## **Planning Commission Staff Report**

**Subject:** Change of Zoning Vote Report

**Petition:** P.Z. 10-2009 84 Lumber (MASE LLC)

# PRELIMINARY DEVELOPMENT PLAN PROPOSED REZONING (PI - PLANNED INDUSTRIAL)

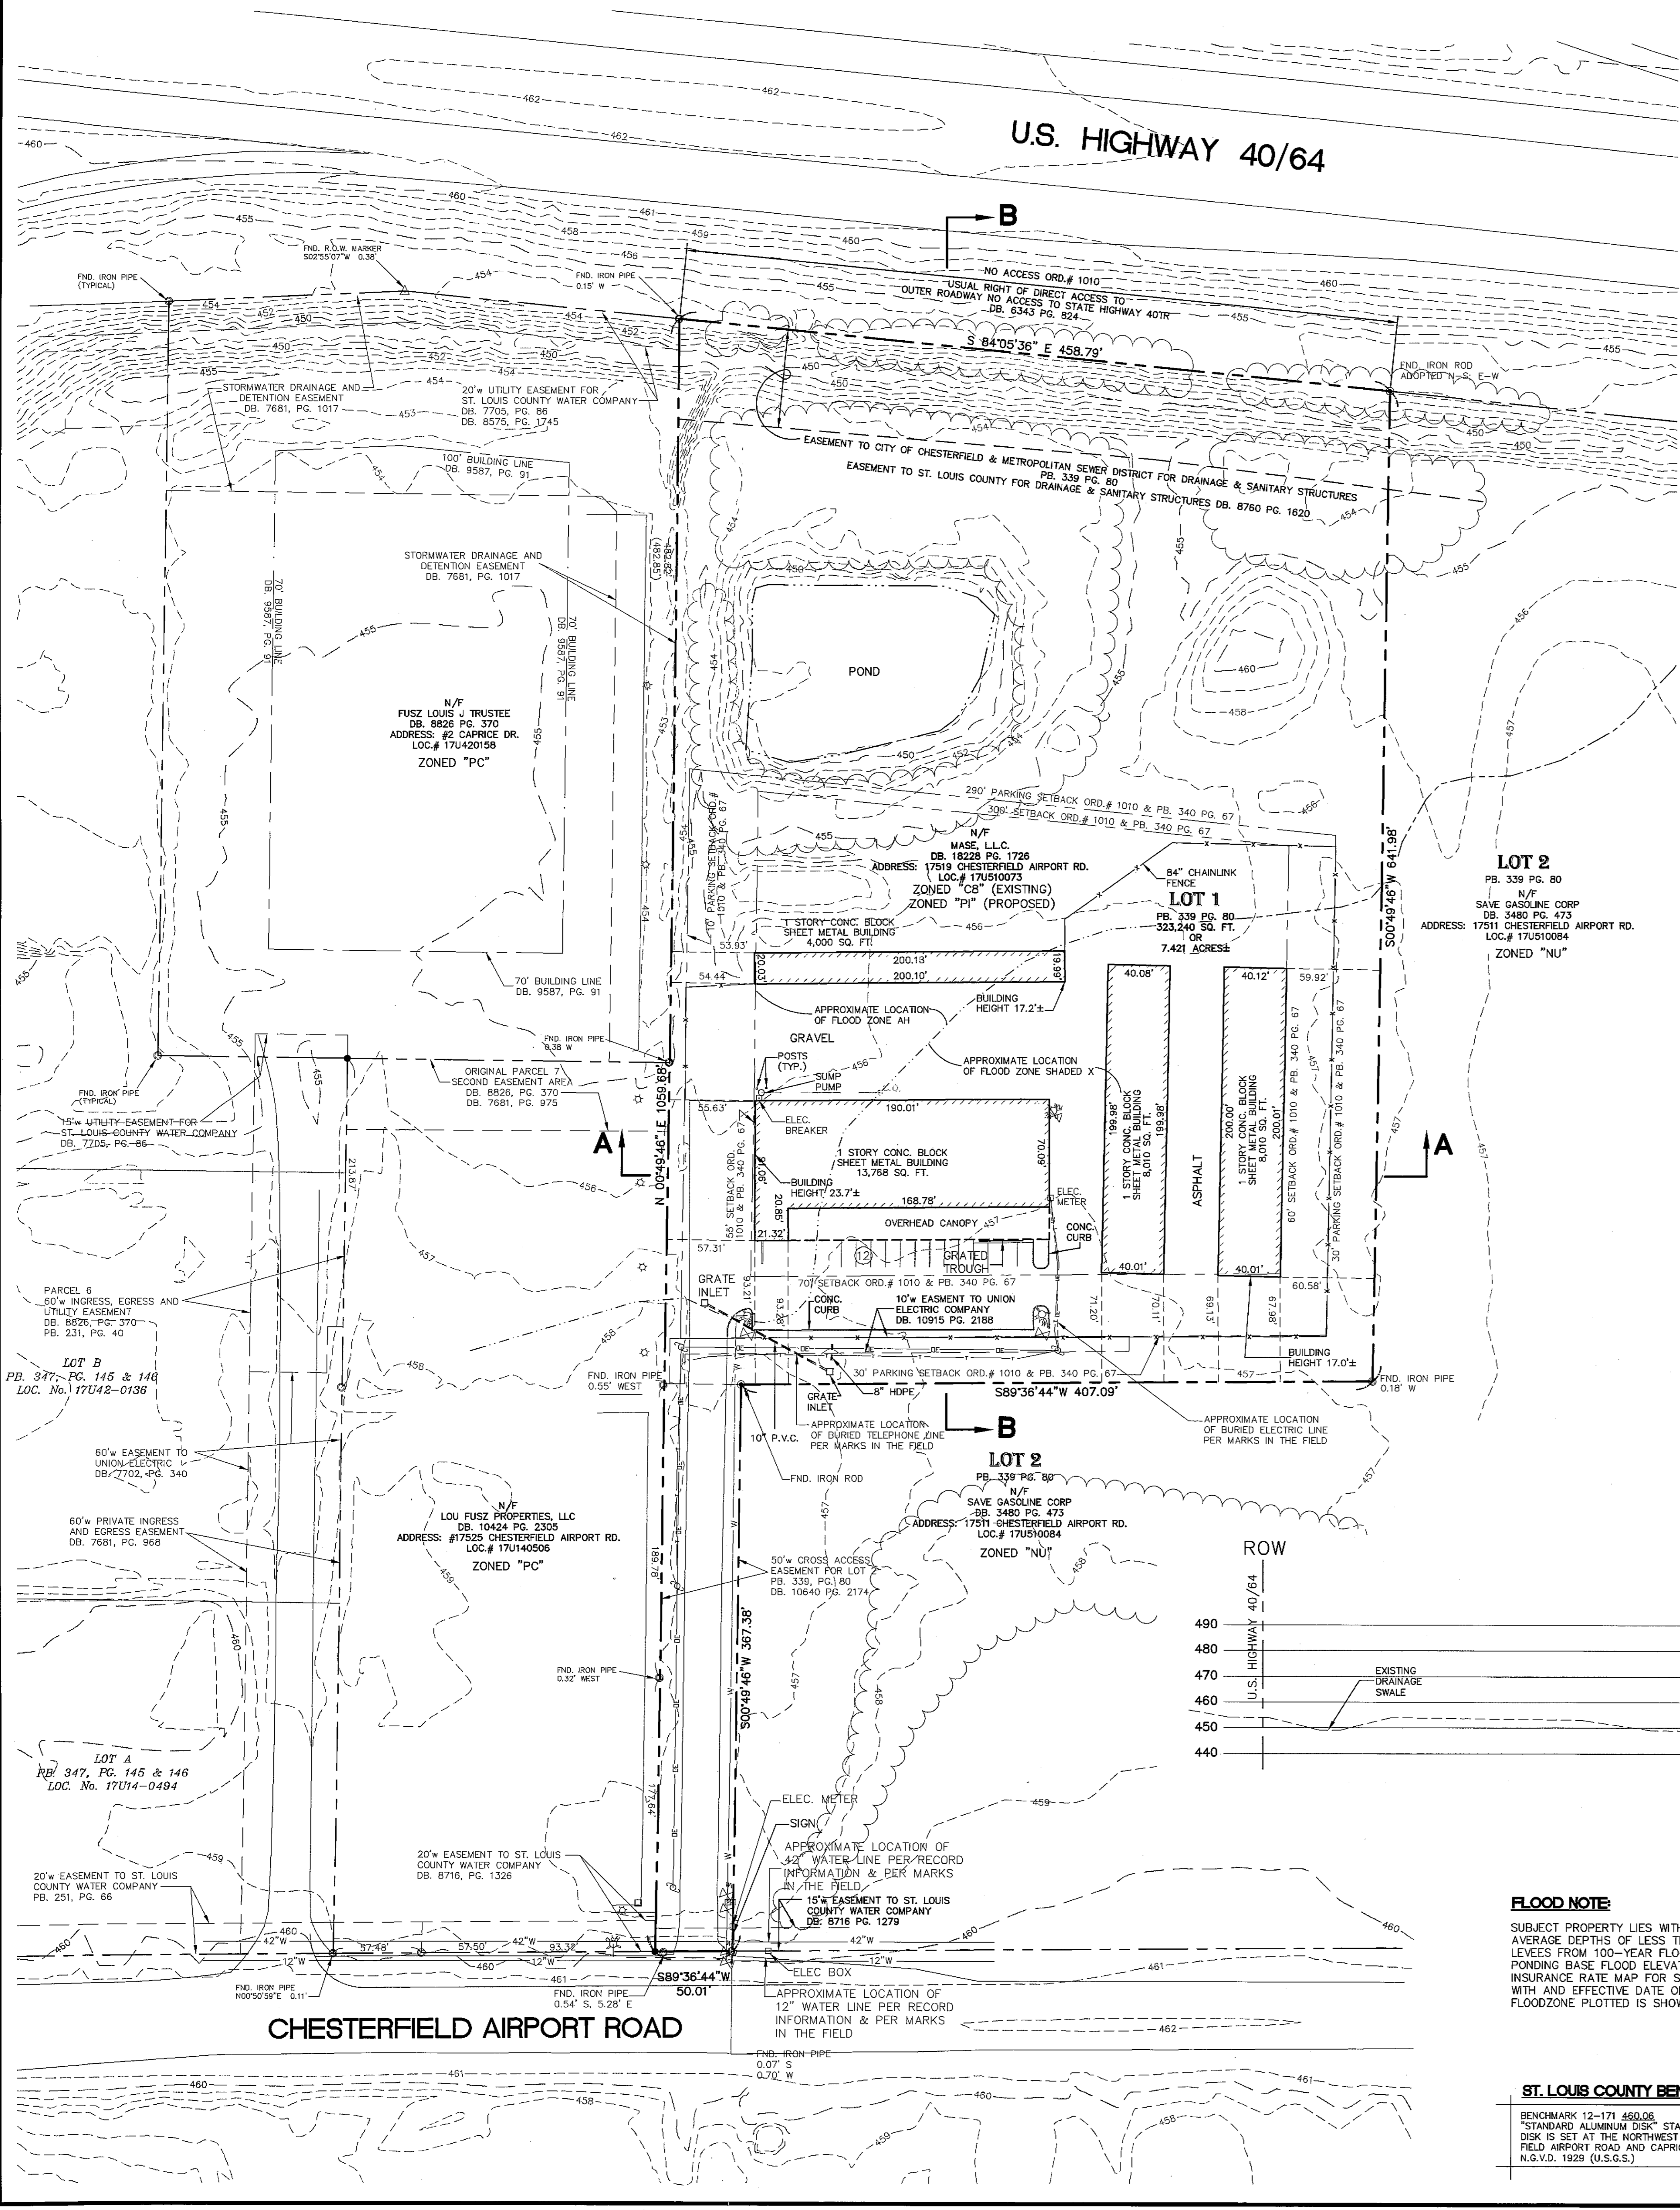
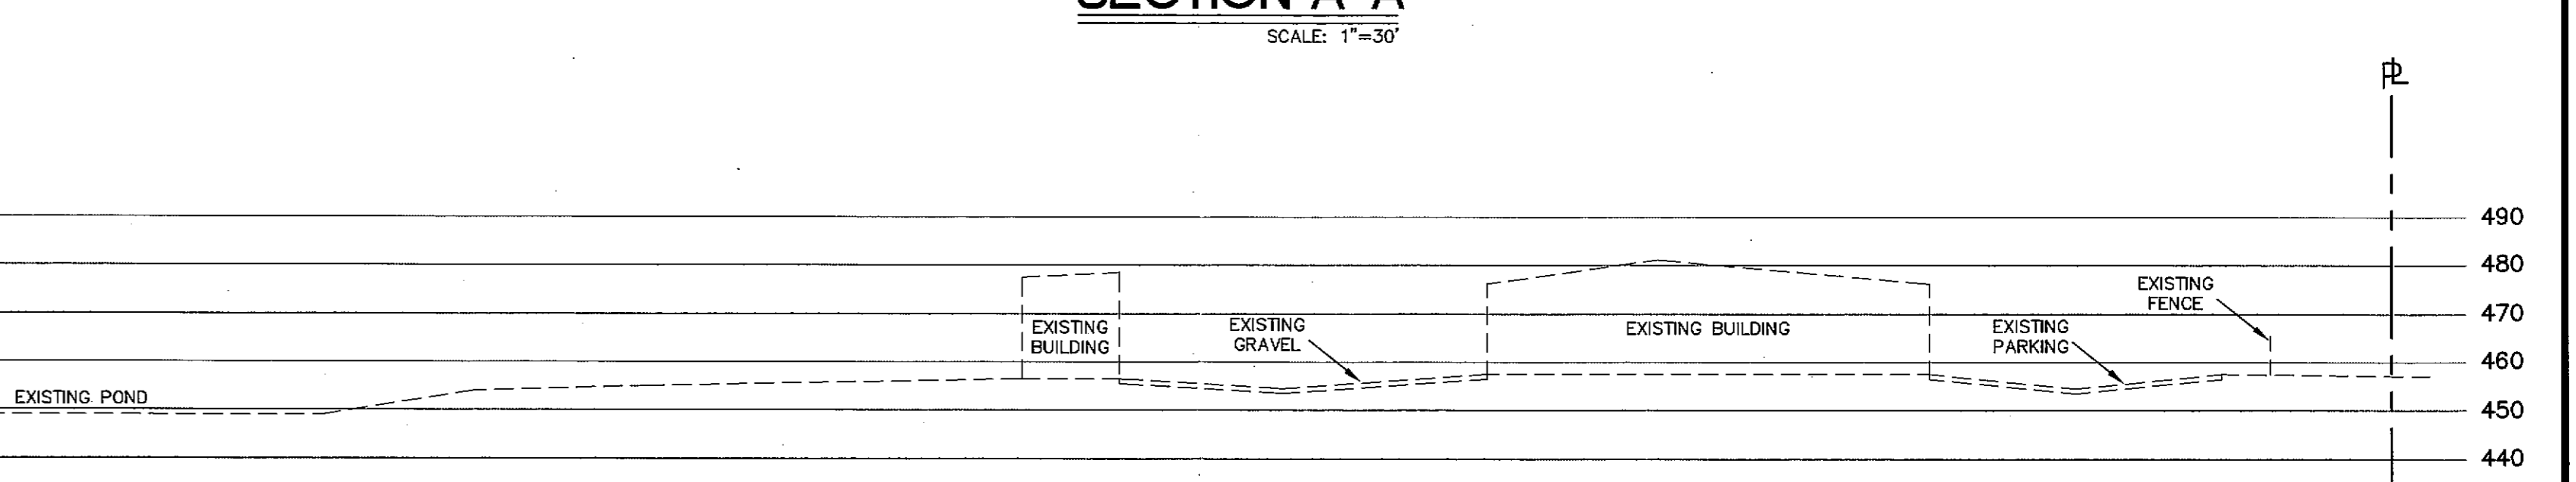
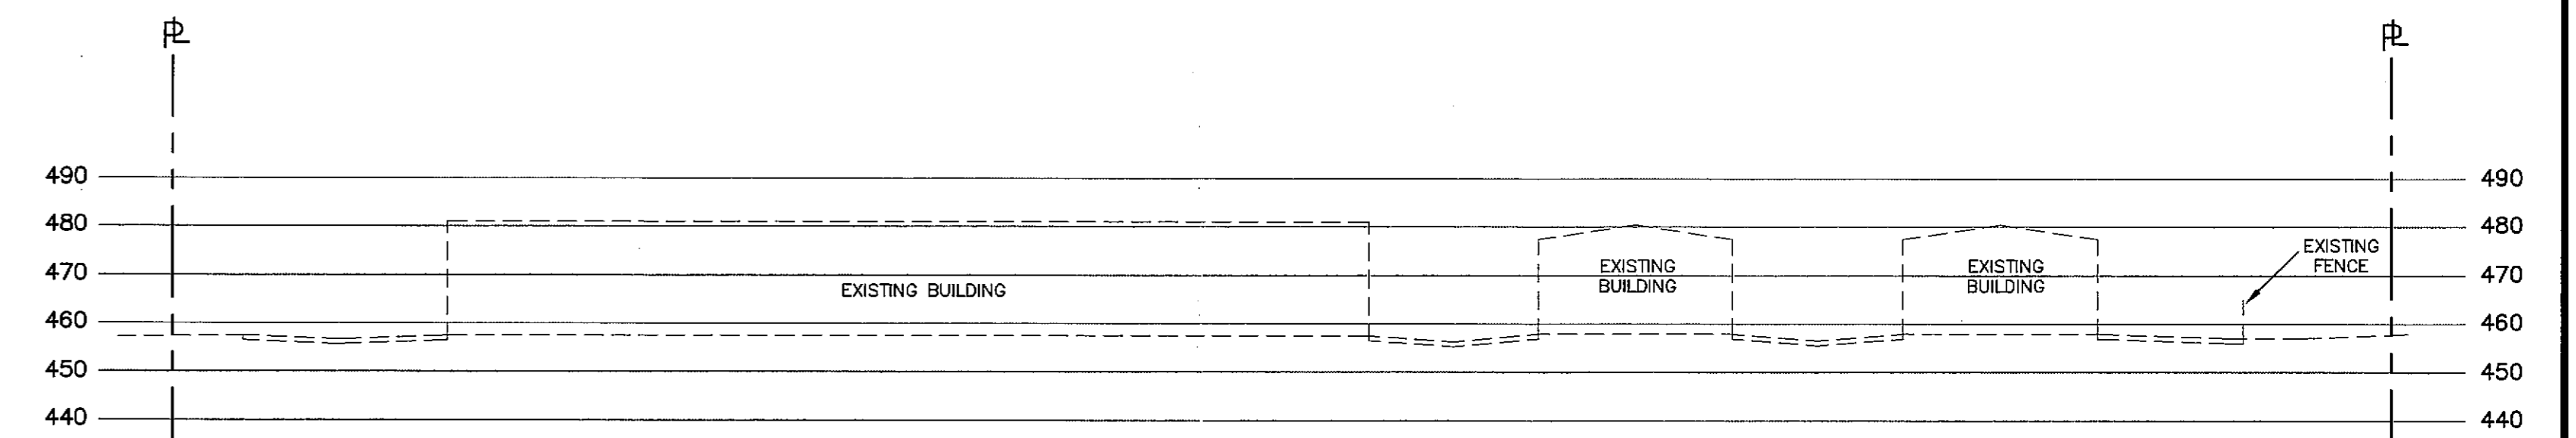
10. Revise the location map on the Preliminary Plan to show the correct parcel.
11. The Missouri Department of Transportation has submitted the following comments:

10. Revised site plan attached.

11 - 12. Petitioner has contacted the MO Department of Transportation and Chesterfield Public Works, and has revised the site plan to show the proposed future required ROW. Additionally, Petitioner will otherwise meet all requirements of MoDOT, Chesterfield
